REPLACEMENT OF ELECTRONIC BOARDS ERF2021 WITH PART NO. 2425138xx

Figure 1

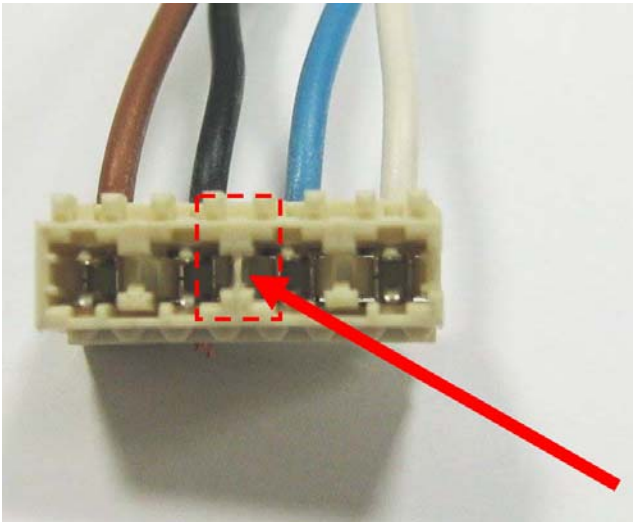
The electronic boards ERF2021 listed in Tab. A have been modified in the area of connector **J2** since the key **K** has been eliminated as indicated in Fig. 1.

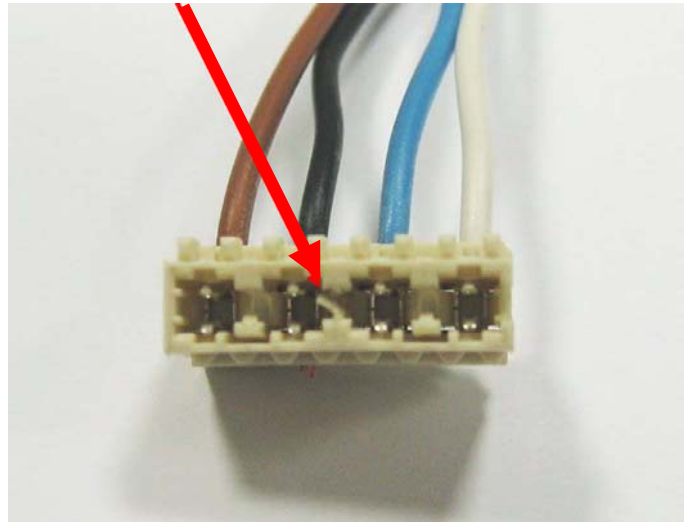
Together with the modification to the electronic boards also the connectors of the electric wiring have been replaced. Therefore, in case of replacement of the old electronic boards with the new ones in the appliances with serial no. previous to 711xxxxx, it is necessary to modify the connector **J2** as follows:

a) Identify the plastic tab positioned inside the 4-pole connector **J2** as indicated by the arrow in figure.

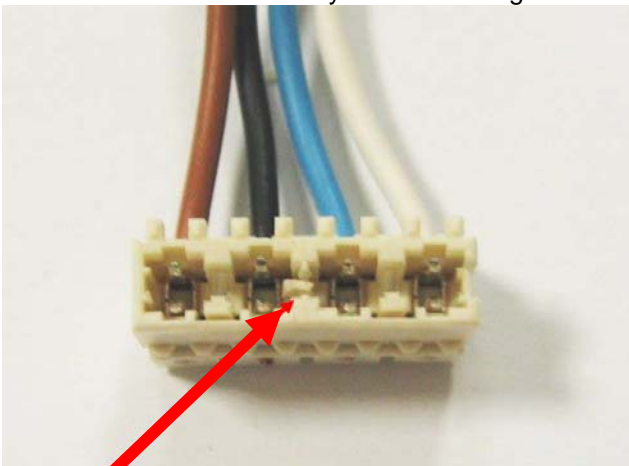
b) Using a cutter make a long cut along the upper part.

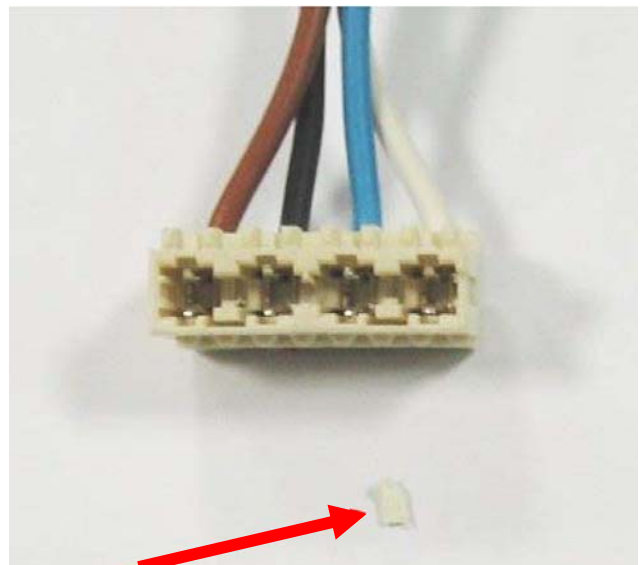
c) Make a long cut along the lower part.

d) Remove the plastic tab from the connector.

ATTENTION: Be sure that the electric contacts are not damaged.
